No. EL/3.2.5

**Modification Sheet No. ELRS/MS/0368 ( Rev. '0')**

**Modification on End Punching and provision of U-shape insulation on slot end portion of armature of TAO-659 Traction Motors of Electric Locomotives.**

**U Shape Insulation for Armature**  
**Slot Ends of TAO-659 TM**

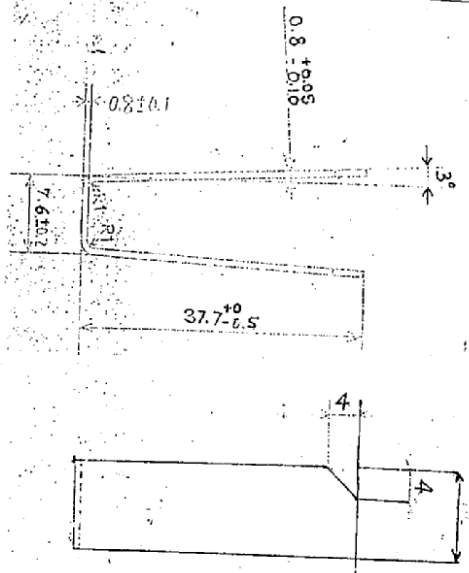
2.3. U-Shape Insulation shall be manufactured as per RDSO Drg. No. SKEL-4752, Alt 'O'. Its material & properties of it is to conform Hitachi specification no 5552/070.

- 4.1. End punchings as per RDSO's Drg. No. SKEL 4751, Alt 'O'.
- 4.2. U-Shape Insulation as per RDSO's Drg. No. SKEL 4752, Alt 'O'. Hitachi Specification no. 5552/070.

1. ALL DIMENSIONS ARE
2. MATERIAL : NOMEX TYPE
- 410 - 30 mil THICK
